November 5, 2009
Subject: **Trenton, Acadia Welcome
Center**
Federal Project No. 16123.50
State Pin No.016123.50
Amendment No. 6

Make the following changes to the Bid Documents:

REVISION TO DETAIL A4/ES-500
TRANSFORMER PAD DETAIL

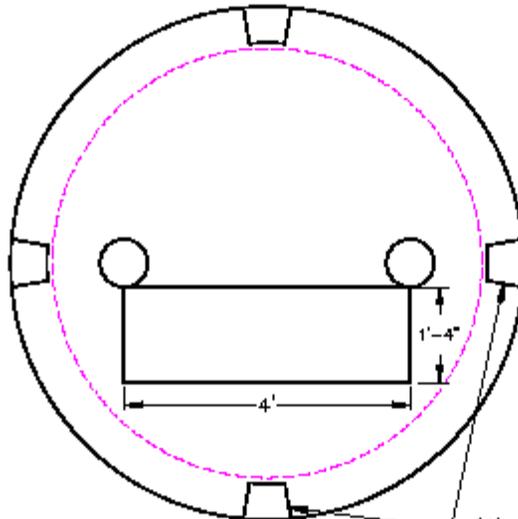
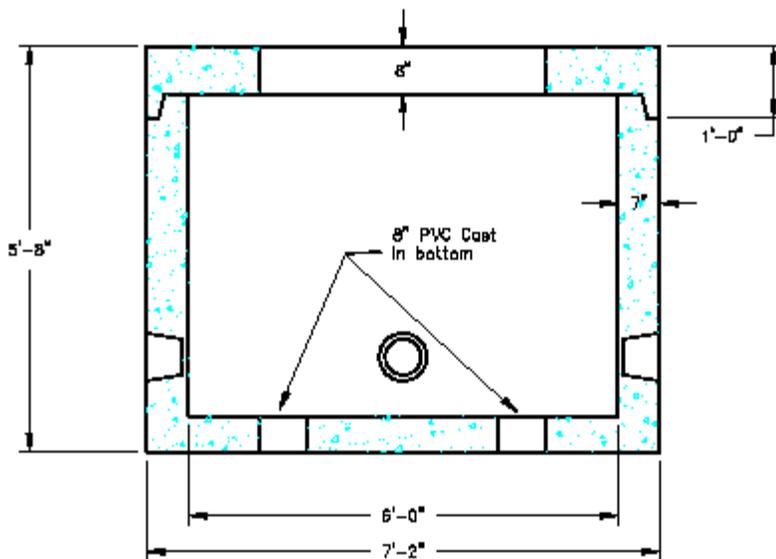
- N. **DRAWING ES-500:** **DELETE** Transformer pad detail A4 in its entirety. **ADD** in its place the transformer vault detail indicated on attached sketch SKE-05.

**Three Phase Transformer Pad - Bangor Hydro
75 KVA to 1000 KVA**

- 1) 4000 psi after 28 days with 4%-6% air
- 2) Reinforcing is grade 60
- 3) Designed for H-20 Wheel Loading
- 4) Conforms to Bangor Hydro Specifications.

REVISED DETAIL E3/SB-500

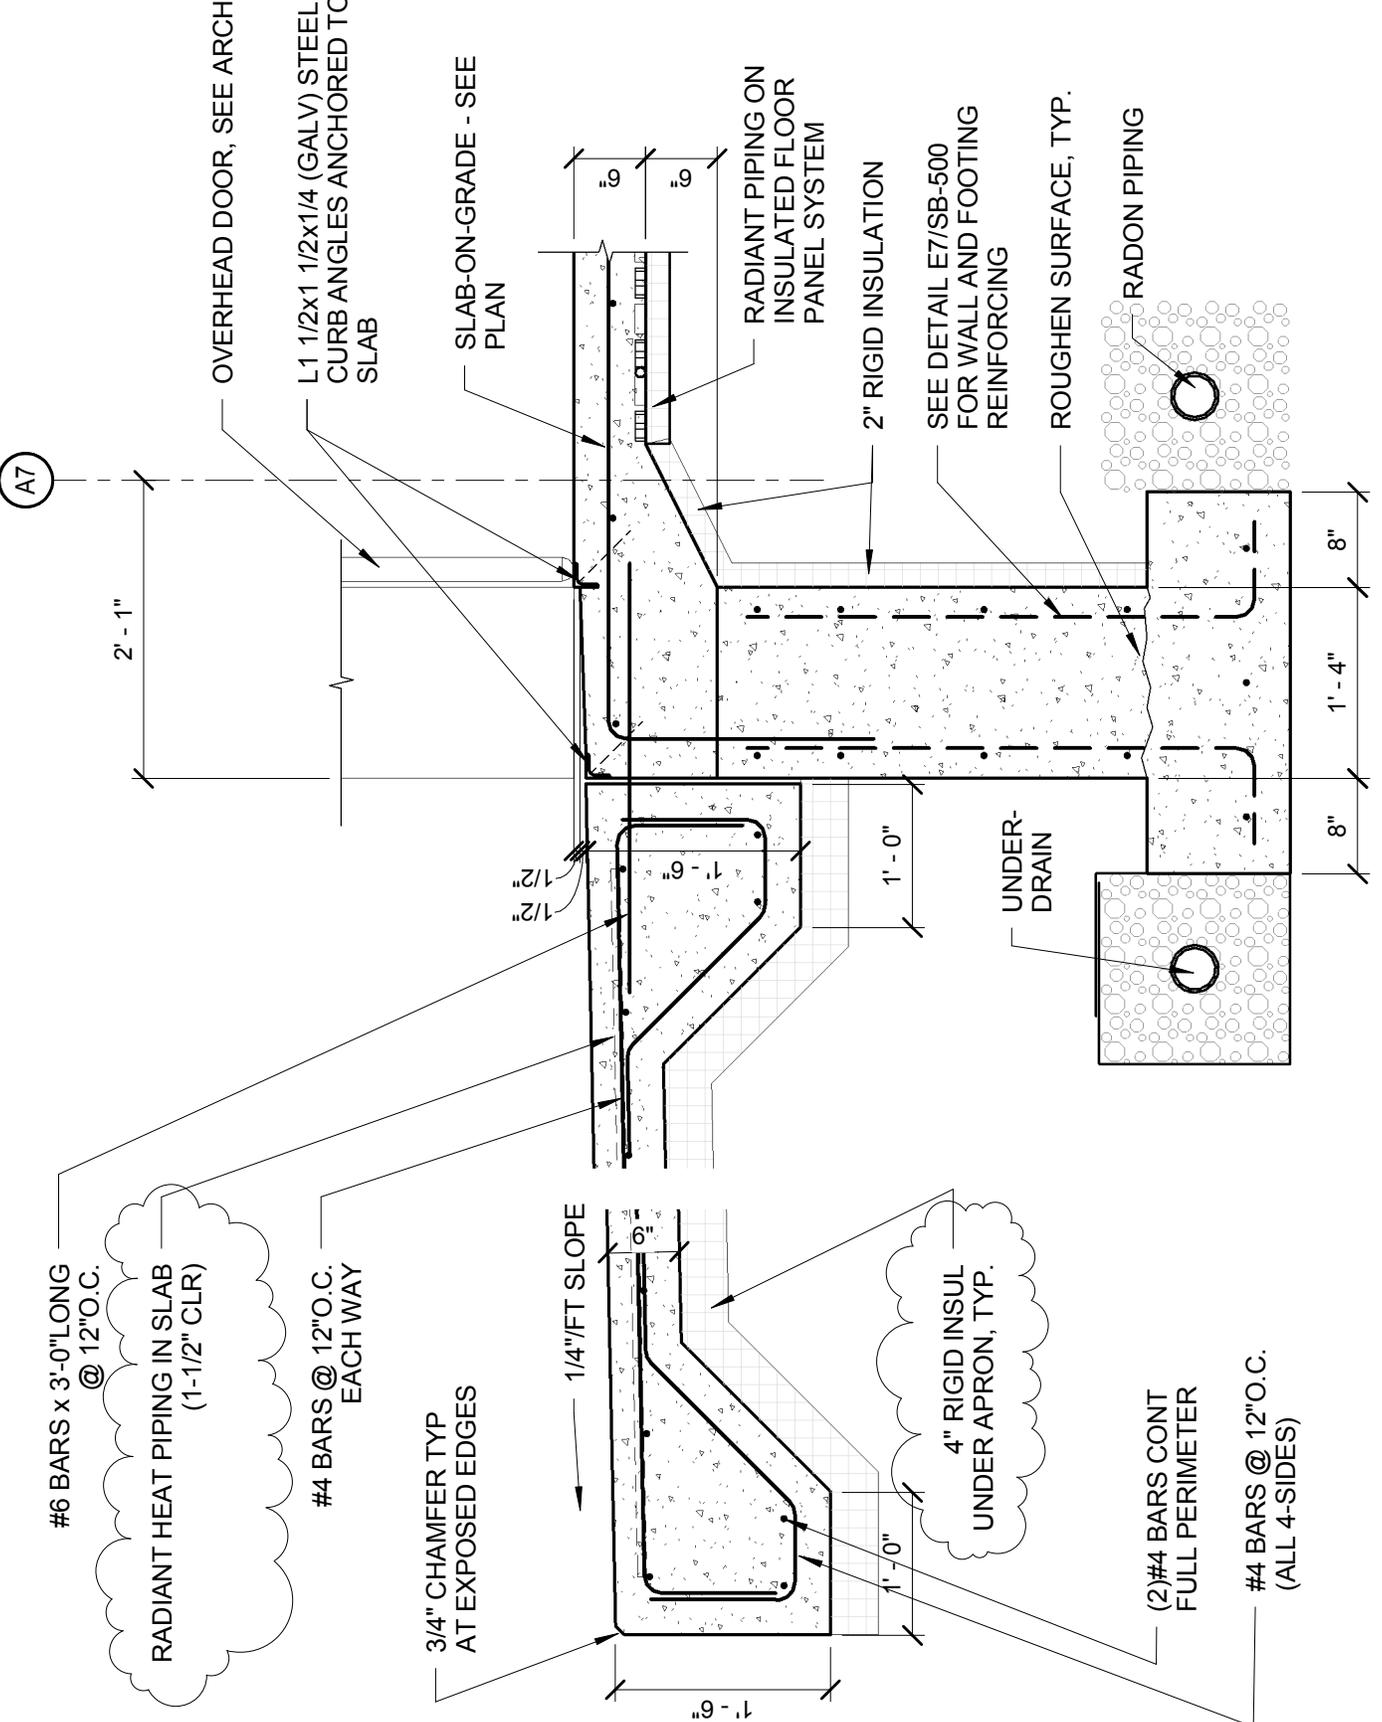
Response: All concrete aprons at the bay ingress/egress locations shall receive 4” rigid insulation beneath the slabs. This is true also for the radiant slab at the egress of the bus wash bay. All sidewalks alongside the building shall receive 4” rigid as well. See attached CSK-1, SKS-01 and SKS-02.
